Section 2.0

Comments and Responses

2.1 INTRODUCTION TO COMMENTS AND RESPONSES

Figure 1. RIX Discharge Record showing steady decline of discharge amounts from 1999 to 2016 and current discharge amounts of approximately 40-45 cfs (Data source: USFWS April 2016, Figure: USGS Jun 2016).

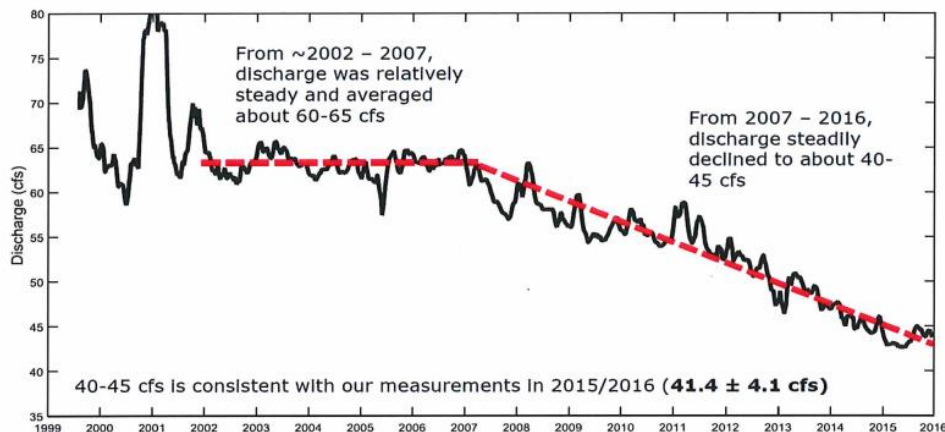
10a

Two points in Figure 1 merit mention. First, the USGS currently estimates discharge from RIX at between 40 and 45 cfs, not the 53 cfs used as the baseline estimate in the Draft EIR. If the real discharge rate is 40 cfs, then the Draft EIR overestimated the baseline (and consequently underestimated the potential effects of the Project by about 1/3. If the discharge rate is 45 cfs, then the Draft EIR overestimated the baseline and underestimated the effects of the Project by 17%. The USGS measurements in 2015/16 were about 41.4 cfs, which would mean that the baseline underestimated potential effects on the environment by about 28%.

Second, the discussion in Table 4.7-5 entirely ignores the very consistent trend line extending from 2007 to the present that has resulted in substantial reductions in the discharge from the RIX facility. As shown in Figure 1 above, this trend has continued for almost a decade in a fairly consistent manner. The baseline should have incorporated this trend into its analysis or given reasons why the trend will not continue. In the absence of those reasons, the Draft EIR's analysis underestimates all effects relating to the discharge of treated effluent into the Santa Ana River by at least 28-33% and probably by a greater factor. This error requires that the City completely revise the Draft EIR and recirculate a revised draft EIR for public review and comment.

The commenter makes a number of assertions related to RIX Facility discharge in response to a graphic published by USGS in 2016. While the points regarding the recent trend in RIX Facility discharge are noted, they did not provide the proper context to the historical trend. The trend identified in the commenter's Figure 1 is the result of the significant economic decline in the service area, which reduced inflow to the RIX Facility, and the elimination of the past practice of maintaining an excessively high rate of

Figure 2. Surface flow lost to infiltration between RIX and Mission Blvd. and a comparison between conditions in 2016 versus 2001 at the same locations (USGS 2016)

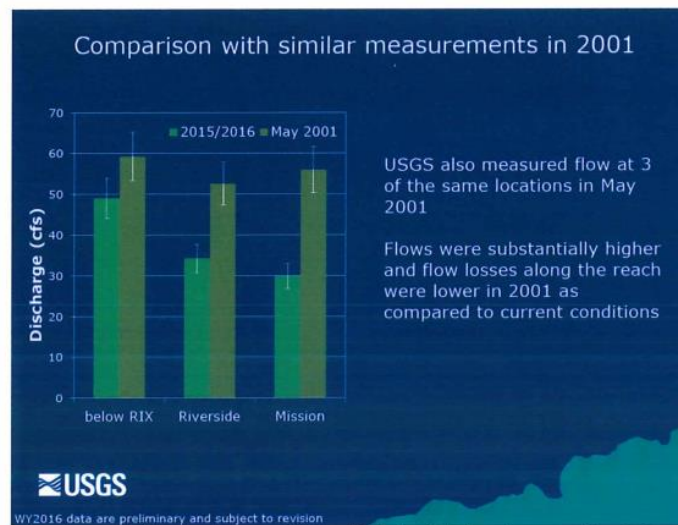
Because the reach of the Santa Ana River below the RIX discharge is a losing reach, the analysis in Table 4.7-5 does not fairly or accurately reflect flows in the Santa Ana River *with* the Project. That table purports to show flows in the Santa Ana River but it ignores the fact that between 10 and 20 cfs of the water discharged into the Santa Ana River is lost between the RIX discharge and Riverside Narrows. If the loss is 10 cfs and that loss rate is added to the effects of the Project described in Table 4.7-5, then the effects of Project would be as follows:
